**syngo.via RT Image Suite running on servers with syngo.via VB60 software after upgrade CT scanners with syngo.CT VA40A after upgrade**

Customer Safety Advisory Notice CT004/22/S

**Subject: Silent change of default Patient Marking workflow setting after upgrading to new RT Image Suite version with syngo.via VB60 or syngo.CT VA40 software**

Fig. 1: Comparison of default workflow setting in VB60 and previous versions (example: VB50).

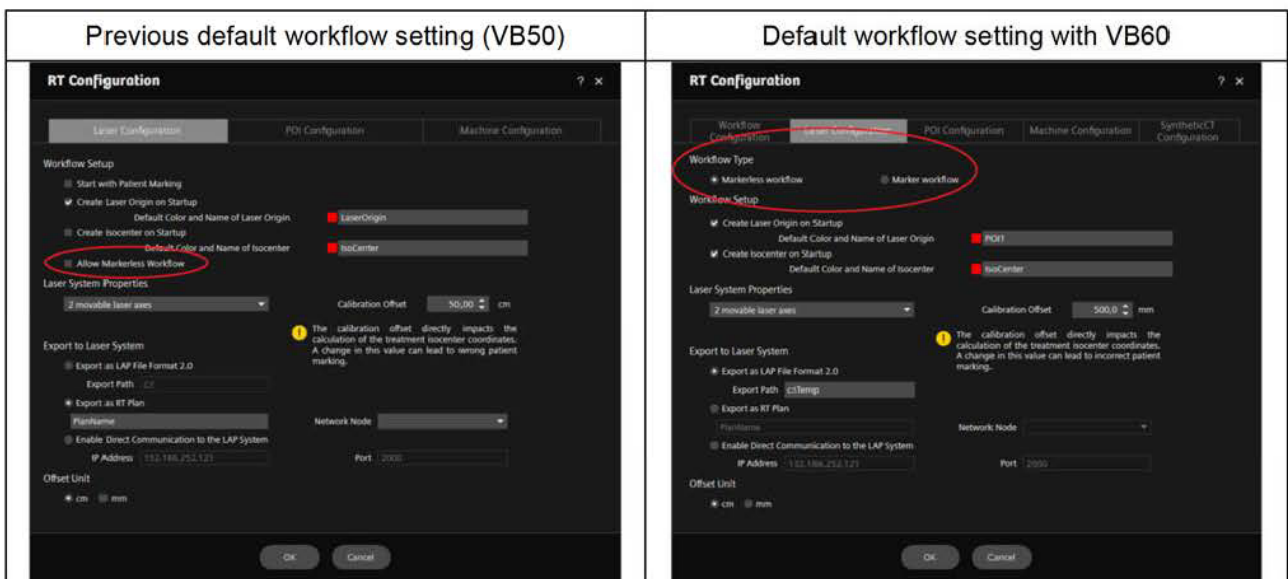
In RT Image Suite versions prior to syngo.via VB60 / syngo.CT VA40, the Workflow Setup “Allow Markerless Workflow” was deactivated by default in the Laser Configuration settings (c.f. fig.1 below, left column). After upgrading RT Image Suite to VB60, this setting is automatically, and without explicit notification, changed to “Markerless workflow” in the new “Workflow Type” section in the Laser Configuration settings with VB60 (c.f. fig. 1 below, right column).

If a marker-based workflow was used prior to the upgrade, then following the upgrade the laser offset coordinates in the Patient Marking step are no longer calculated based on the marker position. If the radiopaque markers are not placed at the laser zero position as described in the "Instructions for Use" (IFU), this may lead to the wrong laser offset coordinates being displayed in the Patient Marking step.

After upgrading RT Image Suite to VB60, please check the Laser Configuration settings in the RT Configuration and adjust the Workflow Type according to your actual workflow. Additionally, it is generally recommended that you "perform a quality assurance procedure after any change to the external laser system or any change to the software application" (c.f. IFU chapter 2.6 and 4) to ensure that the laser coordinates are correctly calculated.

It is sufficient to check that the default Workflow Type is correct. There is no technical update needed.
